**Safety Storage
(Site Plan)**

SAFETY STORAGE SITE PLAN
RT. 207 & TOLEMAN (SHAW)

TOWN OF NEW WINDSOR
PLANNING BOARD
REVIEW COMMENTS

REVIEW NAME: SAFETY STORAGE LLC SITE PLAN
PROJECT LOCATION: NYS ROUTE 207 AND TOLEMAN ROAD
SECTION 29 - BLOCK 1 - LOT 26.221
PROJECT NUMBER: 99-12
DATE: 12 MAY 1999
DESCRIPTION: THE APPLICATION PROPOSES SELF-STORAGE MINI-WAREHOUSES ON THE SITE. THE PLAN WAS REVIEWED ON A CONCEPT BASIS ONLY.

Drawing: **GRADING PLAN & DETAILS**

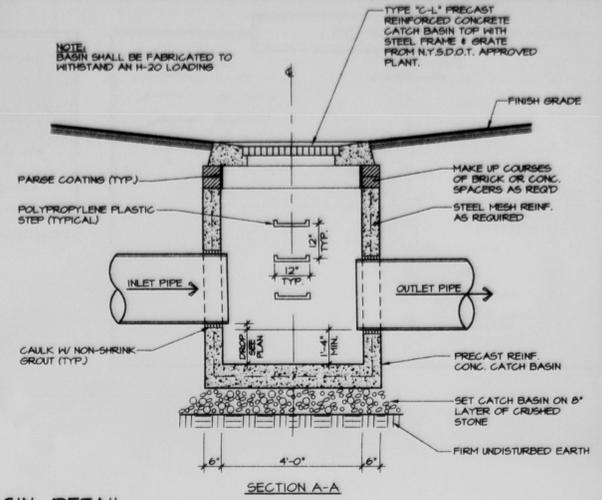
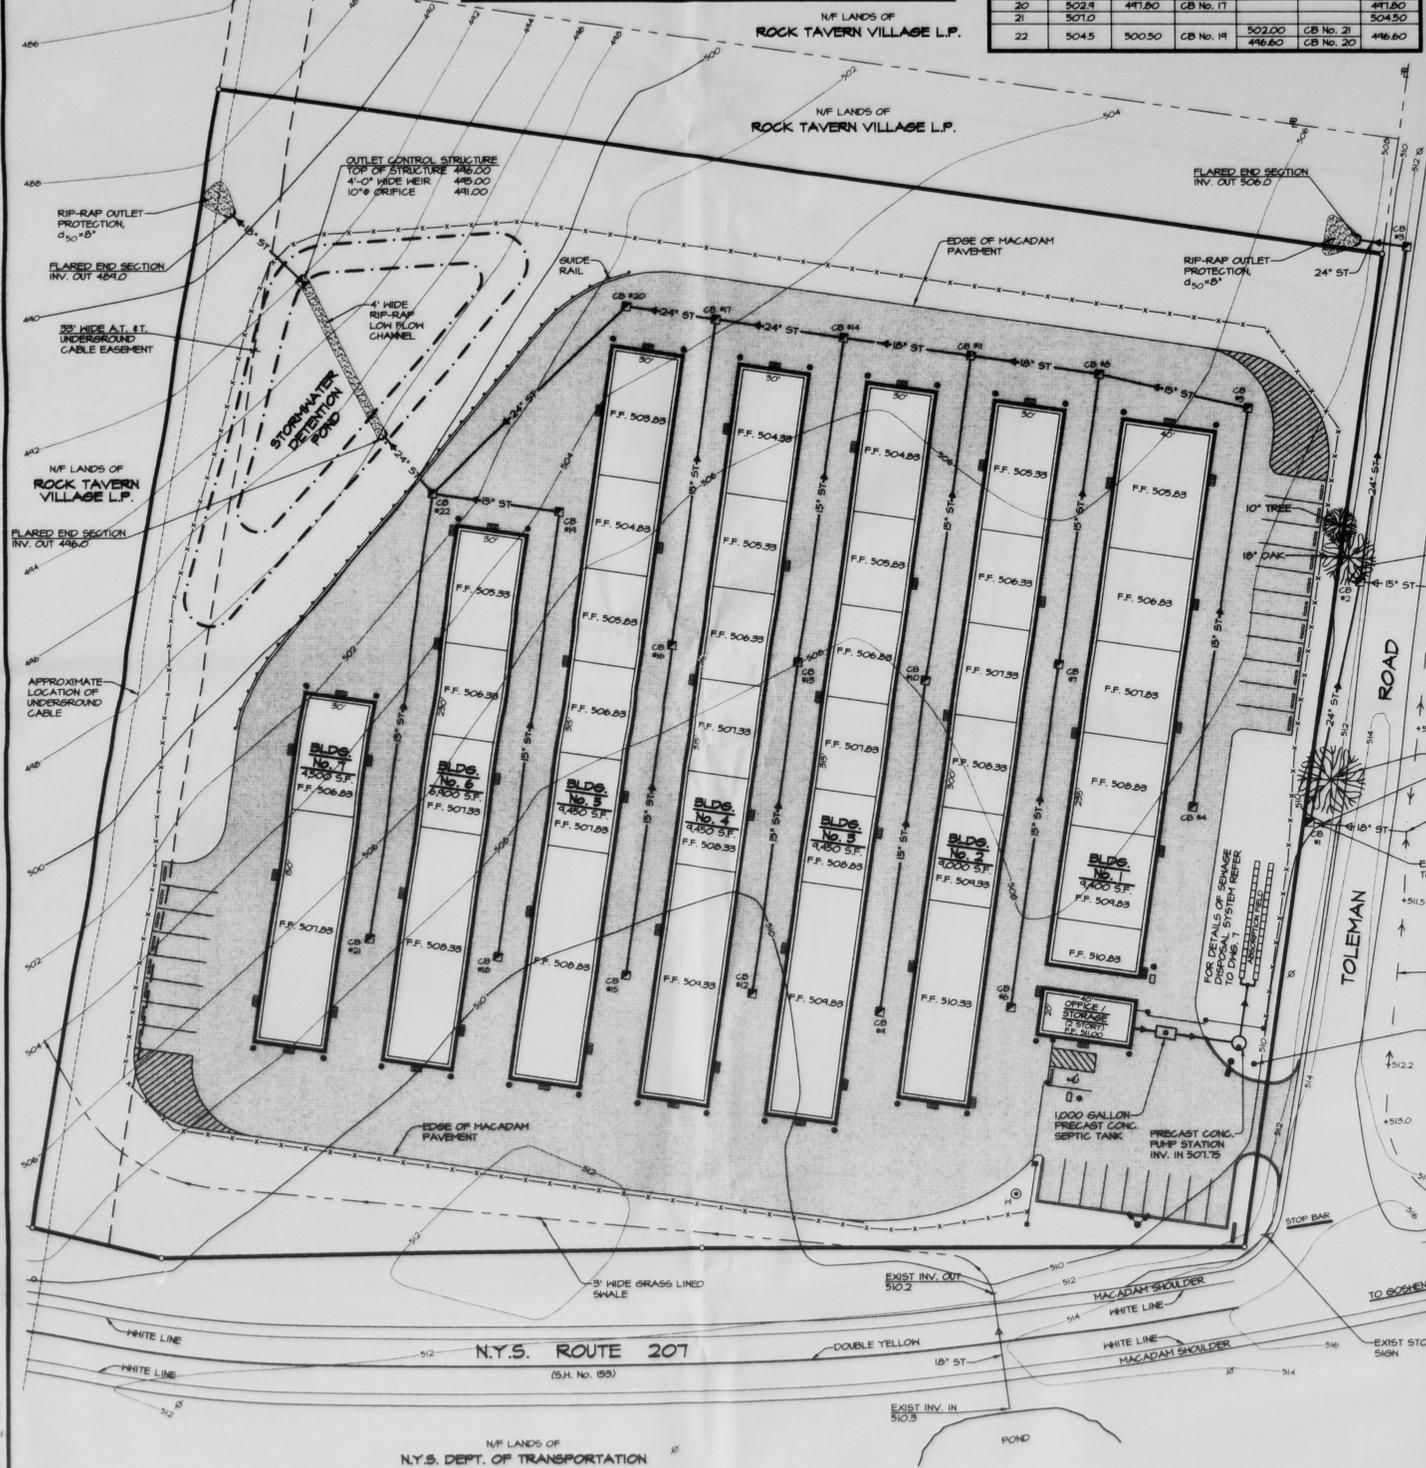
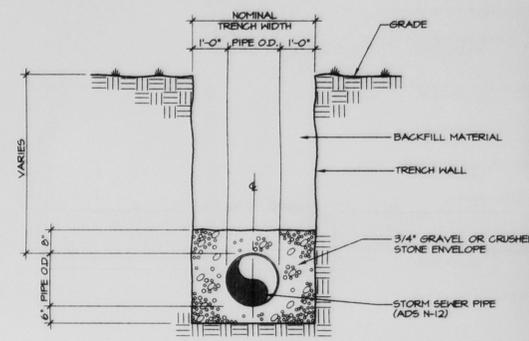
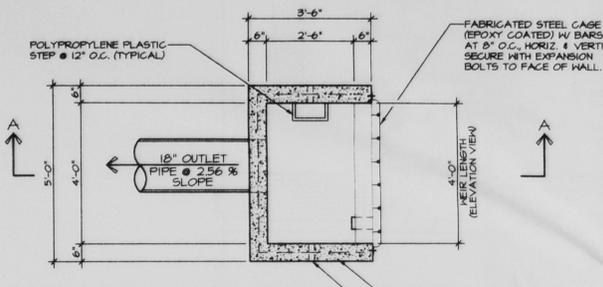
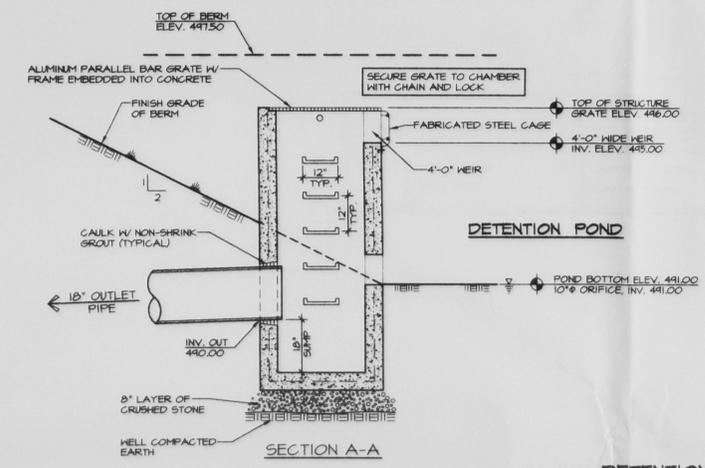
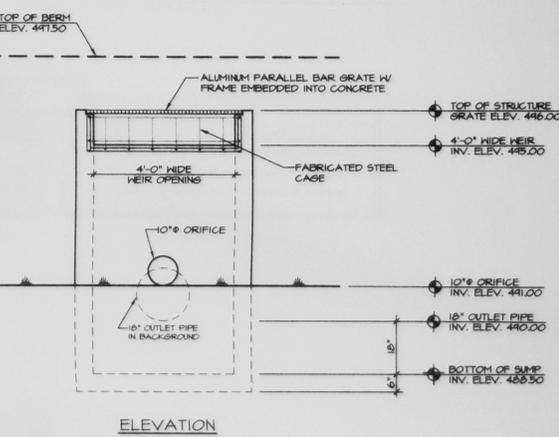
- e. Some free-standing one-way signs should identify the one-way clockwise exterior traffic flow proposed.
 - f. The chainlink fence detail on drawing 2 should acknowledge that some fences are black vinyl fence and some are galvanized with green privacy slats.
